APP-GW-GLR-033, Revision 0
“Spent Fuel Storage Rack Structure/Seismic Analysis”

TITLE: Spent Fuel Storage Racks Structure/Seismic Analysis

AP1000 Standard Combined License Technical Report

Spent Fuel Storage Racks Structural/Seismic Analysis

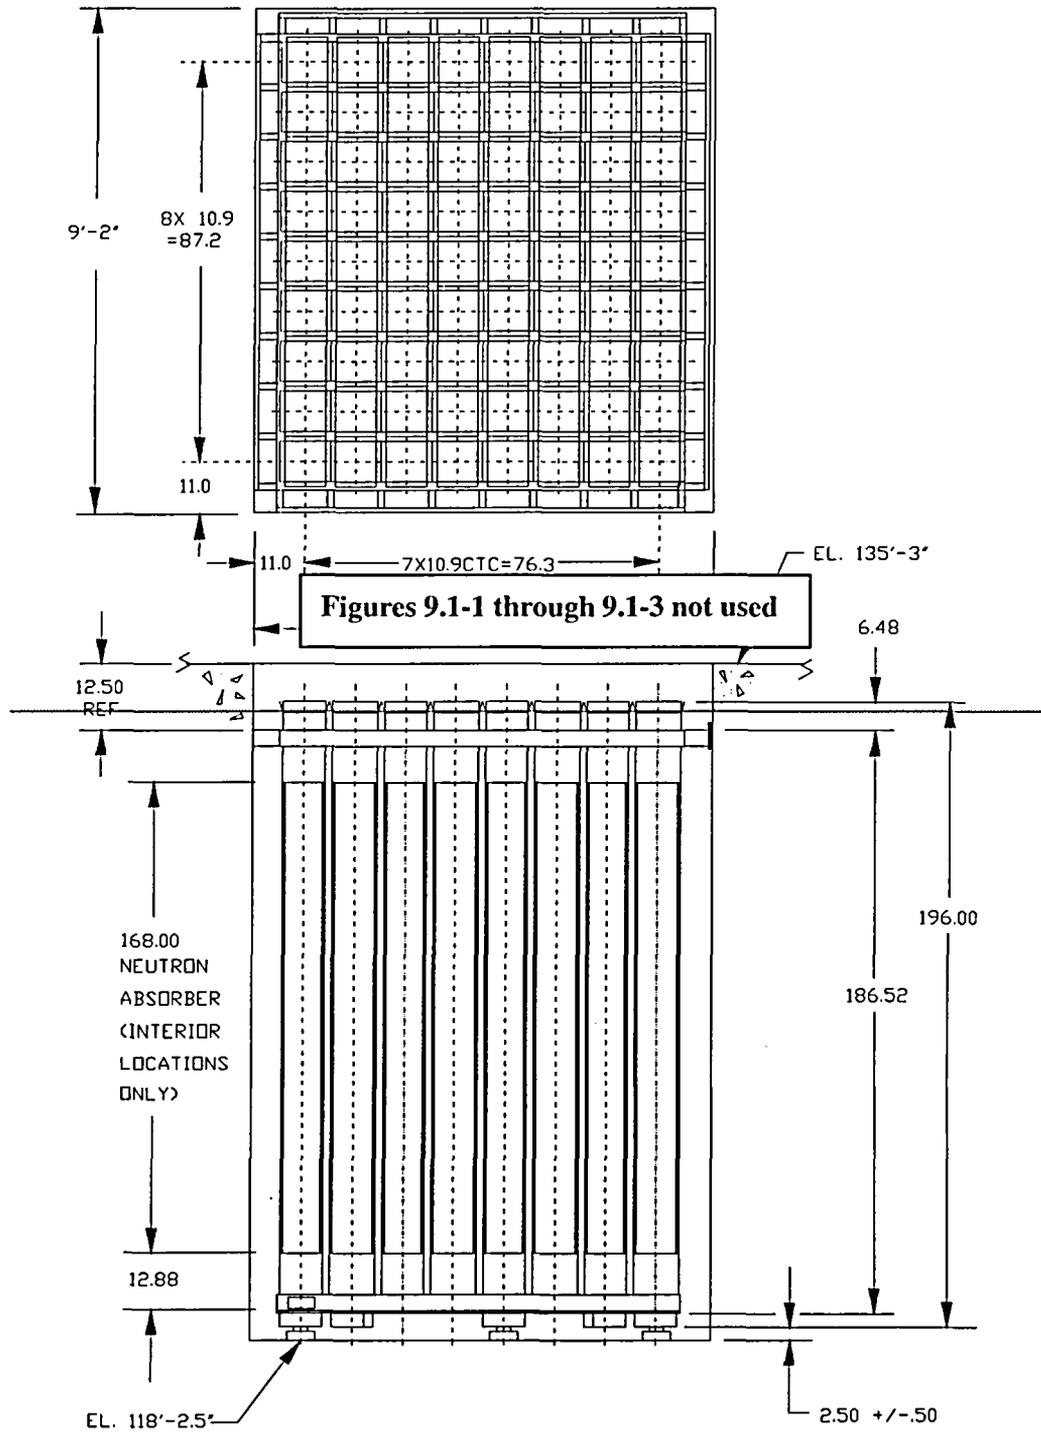
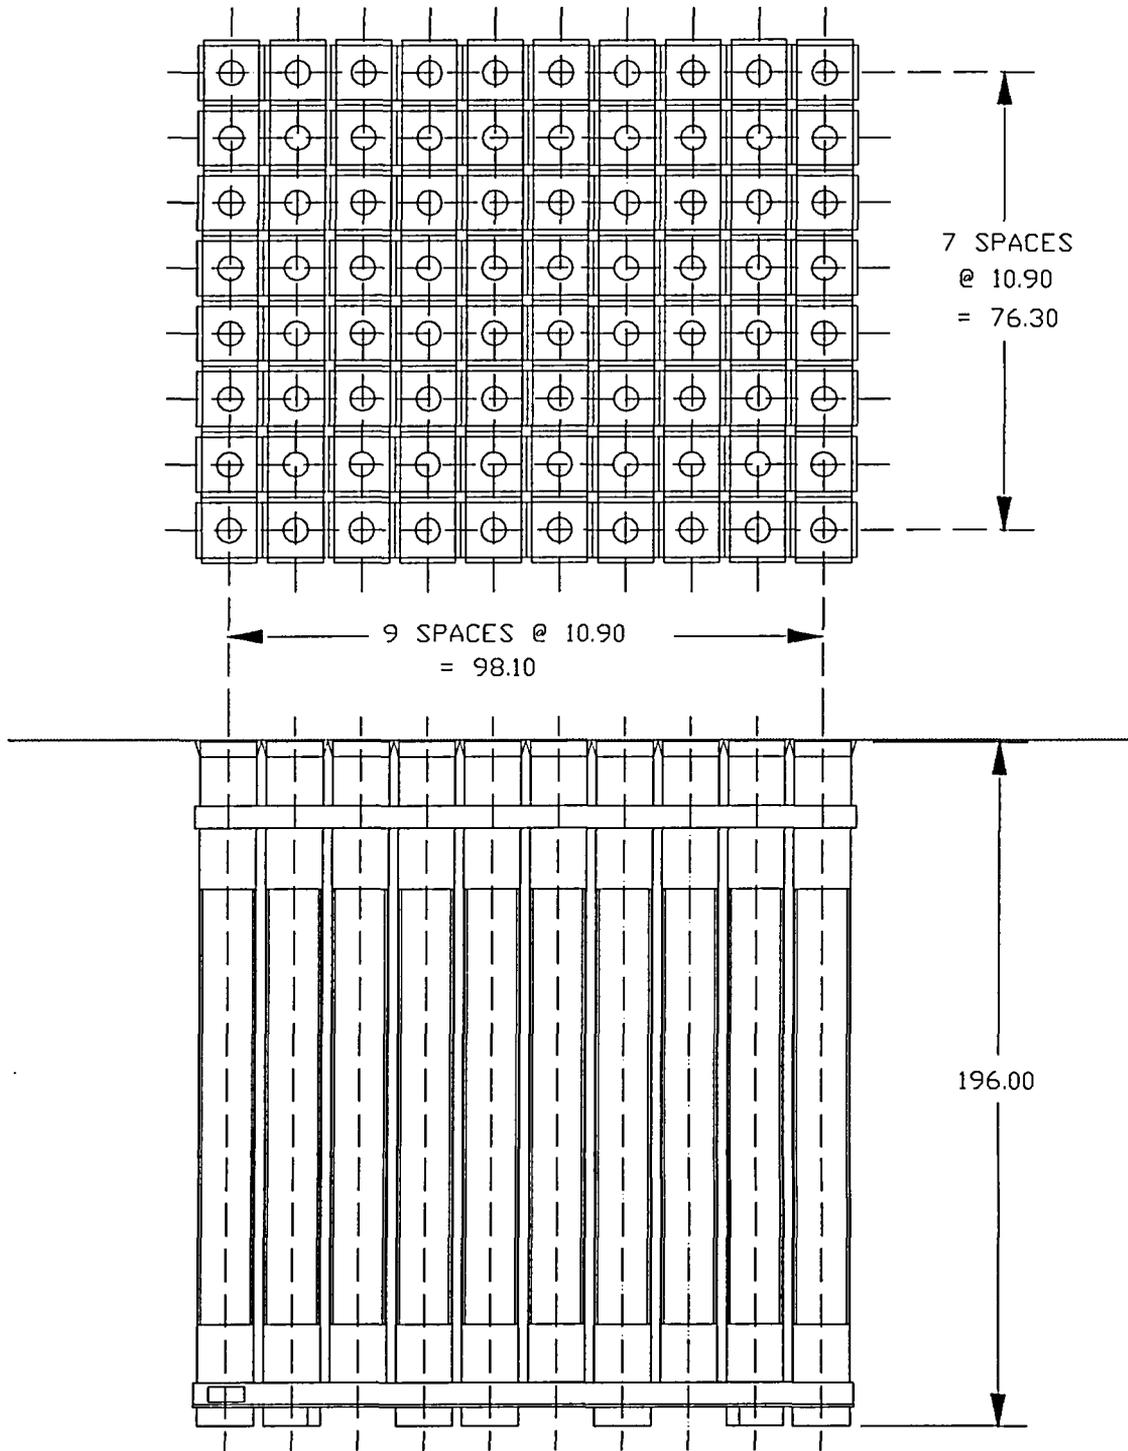
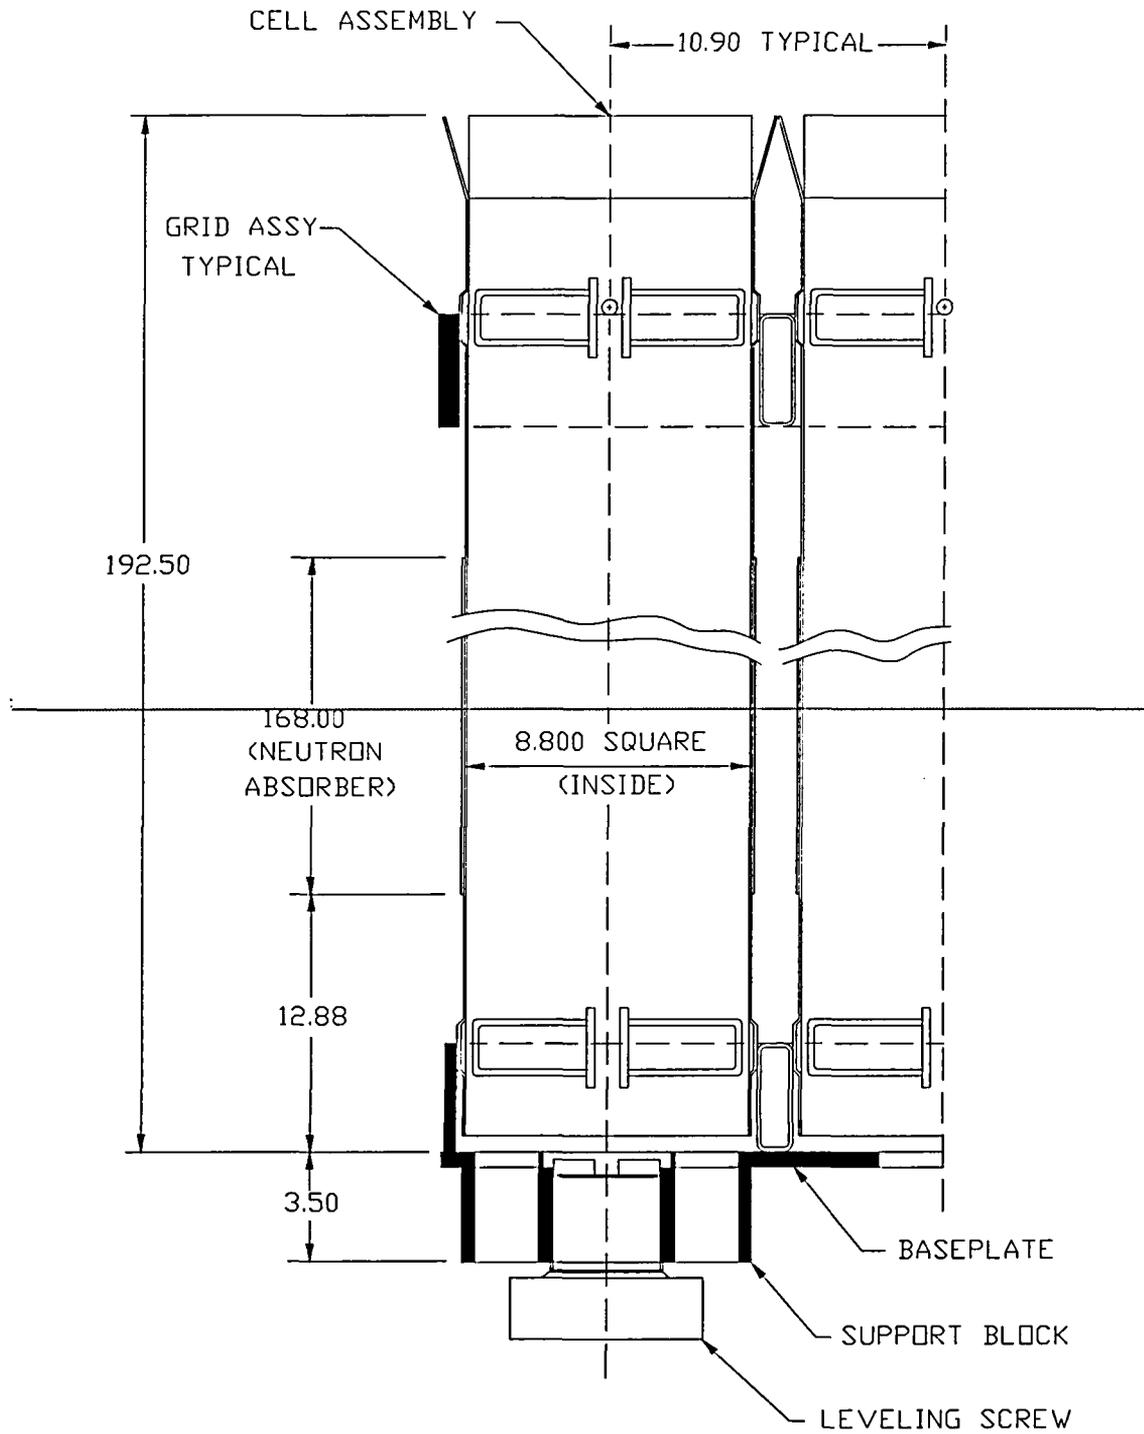
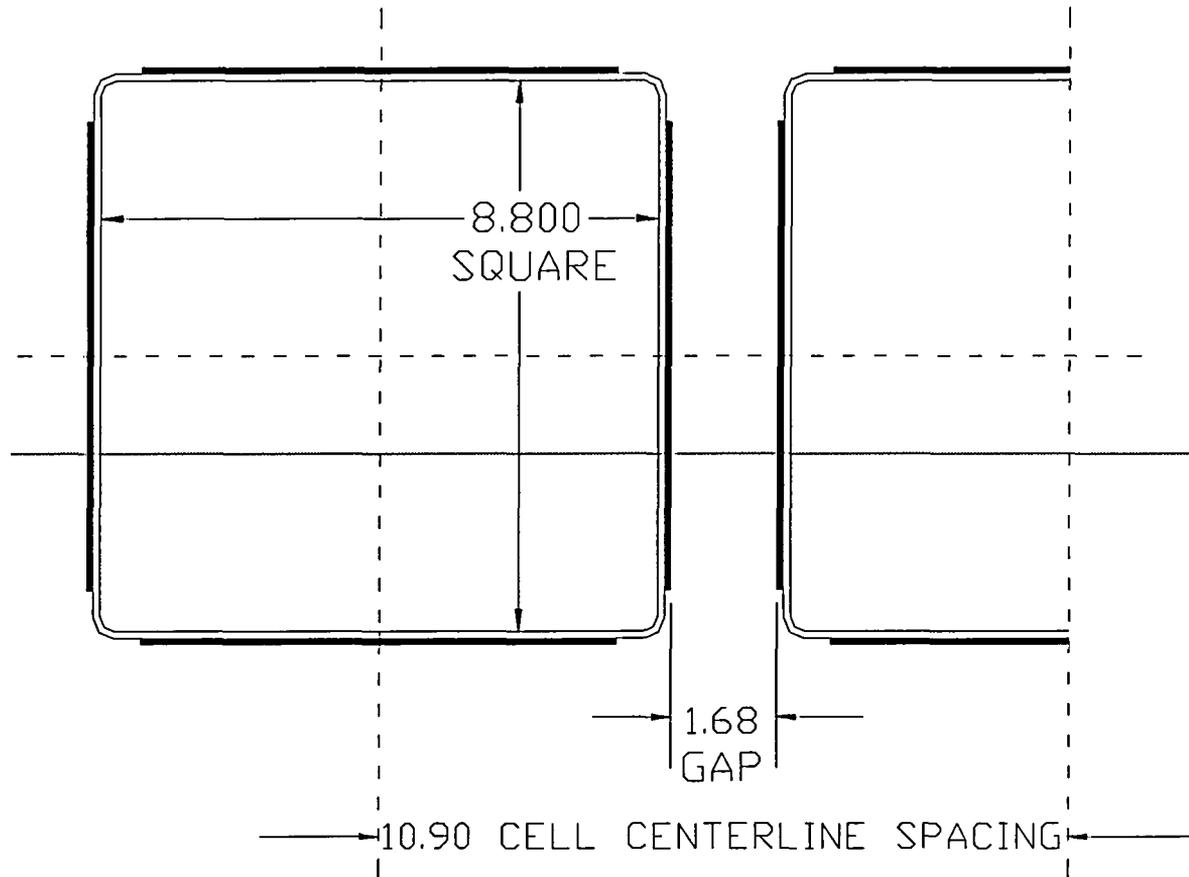
Revise the figures of Section 9.1 as listed below and as shown on the following pages:

- Delete Figures 9.1-1 through 9.1-3 by indicating “Figures 9.1-1 through 9.1-3 not used.”
- Replace Figure 9.1-4 with a new Figure 9.1-4.
